TRANSGRID REVISED REVENUE PROPOSAL

An independent review

Document Reference: AER_Revised_TG2009Reset_Main_V8_0.doc

Date Issued : 23 April 2009

Figure 4-1 – System average age, across asset classes

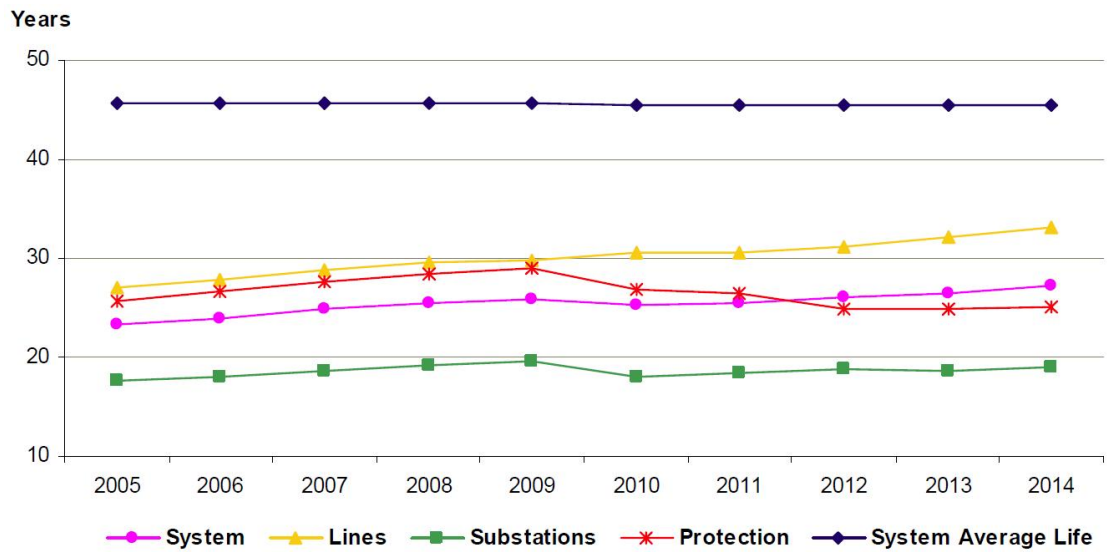
In response to this matter, PB accepts that at a macro level the analysis is correct as the ratio of new assets proposed to be constructed during the next regulatory period compared to the number of assets in the existing asset base is very small. The impact of the proposed capital expenditure on the individual asset classes is shown in Figure 4-1, where it can be seen by example that the average life for the Protection and Substations asset classes reduces over the period but the impact on the entire system average life is very minimal. For the critical asset class of substations, PB notes that the average age is reduced slightly over the period 2009 to 2012.

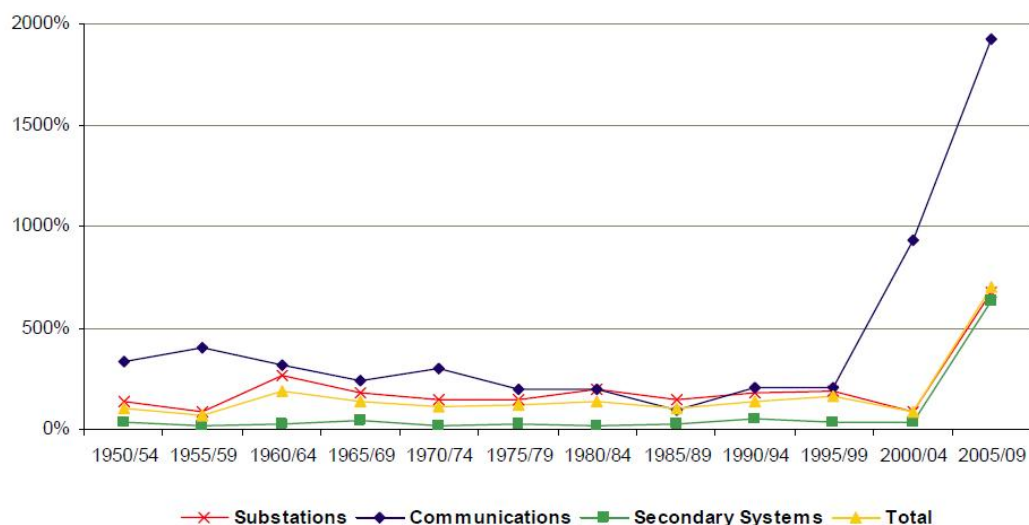
Whilst SKM goes on to conclude that the defect rate used in TransGrid’s model and applied to new assets is appropriate because TransGrid has demonstrated that the average age for various asset categories and the system itself remains largely static, PB considers the above statement also highlights that the higher rates of defect for new assets primarily result from manufacturing defects, “burn in” failures and design and installation issues, which we believe are usually rectified within the standard warranty periods. After the warranty periods, PB expects that new assets should generally have lower maintenance costs than assets commissioned during previous regulatory periods.

Figure 4-3 – Defect ratio vs. commissioning date (ex HYM)

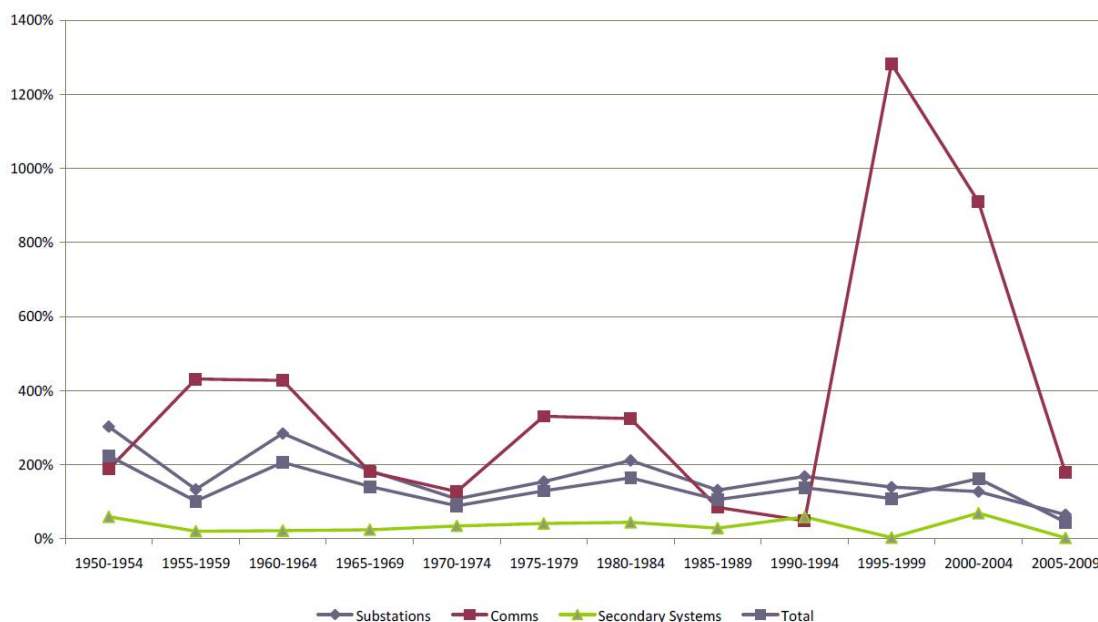
Figure 4-3 details the impact of the adjustments made by TransGrid, and generally the revised data shows a reduction in total asset defect ratios for a given commissioning date over the current regulatory period based on costs incurred during the period 2006/06 to 2007/08 only. Even though the survey period was limited to two years data, PB notes that this figure demonstrates that the substation defect ratio has consistently been lower for equipment commissioned since the period 1990-1994. PB has no reason to believe that extending the survey period would change the trends evident in Figure 4-3. Our view is that this trend and the average switchbay maintenance cost trend support our contention that average maintenance costs for newly commissioned assets will be lower during the regulatory period in which they are commissioned compared to assets commissioned during previous regulatory periods.

Figure 4-3 also indicates that secondary system defect ratios are lower for equipment commissioned in 2005-2009 than for equipment commissioned in 1990-1994. The total defect ratios show a generally reducing trend over the periods 1990-1994 to 2005-2009, even though there was a significant spike in communication defect ratios for equipment commissioned over the same period. However, PB contends that the downwards trend of the total defect data supports our position that newer assets have a lower defect ratio and experience lower maintenance costs than assets commissioned in previous regulatory periods after the expiry of warranty periods, especially in the key category of substations.

Figure 4-9 – Average maintenance cost / switchbay (ex HYM)

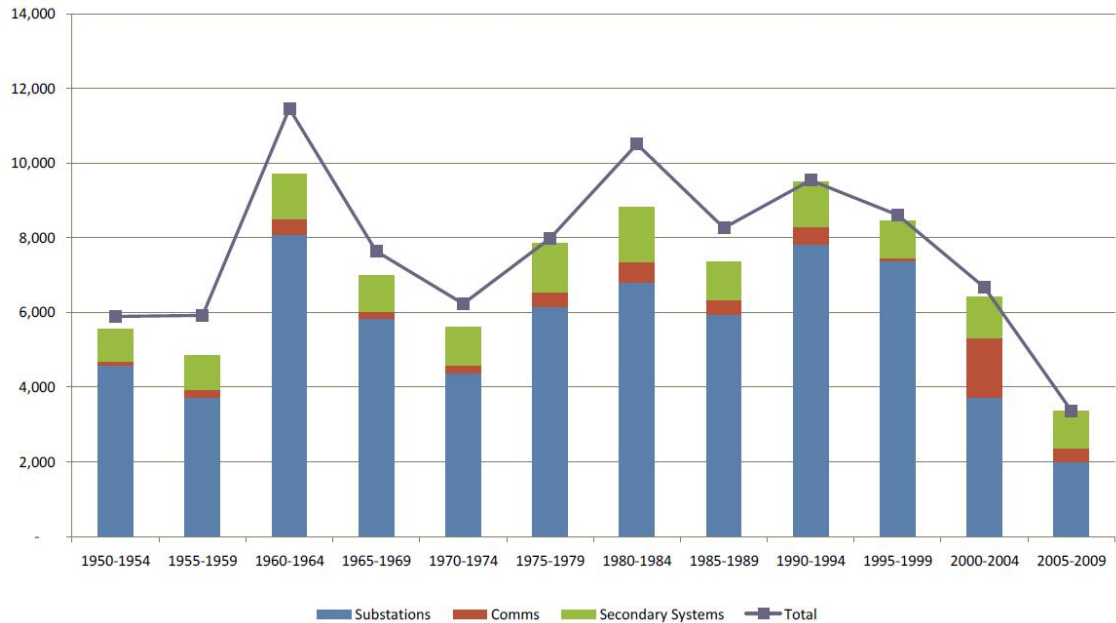
Figure 4-9 clearly shows the trend of falling average maintenance costs per switchbay for assets commissioned since 1990 and the significantly lower average substation maintenance costs for assets commissioned during the current regulatory period when the impact of the MetroGrid project is removed.

PB considers this result further supports our assertion that newly commissioned assets have lower average maintenance costs than older assets, implying also lower defect rectification costs than older assets.
